Authorized Field Change

AFC 14905R1

Subject File: Engine

Subject: Lower Radiator Hose Rub.

Figure 1. Z-Bracket Replacement.

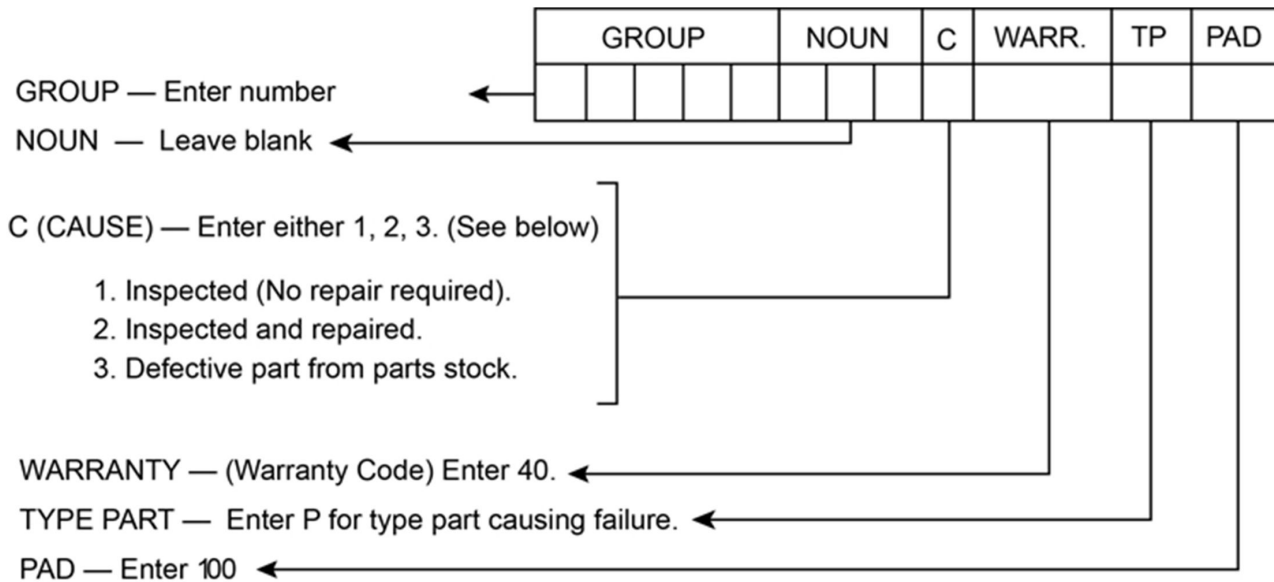
Certain DuraStar® vehicles and CE buses built between 10 February and 26 August 2014 with ISB engines, may experience a rub condition with the fan shroud on the one piece lower radiator hose. This procedure provides the steps necessary to inspect for potential interference and correct if this condition exists.

1. Bolt, lockwasher, and nut (2)
 2. Z-bracket (2)
 3. Bolt and nut (2)
1. Remove two nuts, bolts, lockwashers (Figure 1, Item 1), and hose clamps from Z-brackets (Figure 1, Item 2).
 2. Remove two nuts, bolts (Figure 1, Item 3), and Z-brackets (Figure 1, Item 2) from vehicle. Discard Z-brackets.
 3. Install two new Z-brackets (Figure 1, Item 2) on vehicle with two bolts and nuts (Figure 1, Item 3).
 4. Install two hose clamps onto two Z-brackets (Figure 1, Item 2) with two new lockwashers, bolts, and nuts (Figure 1, Item 1).
 5. Verify clearance between lower radiator hose, fan shroud, shackle, and washer is a minimum of 1/4 inch.
 6. Close and latch hood.
 7. Remove wheel chocks.
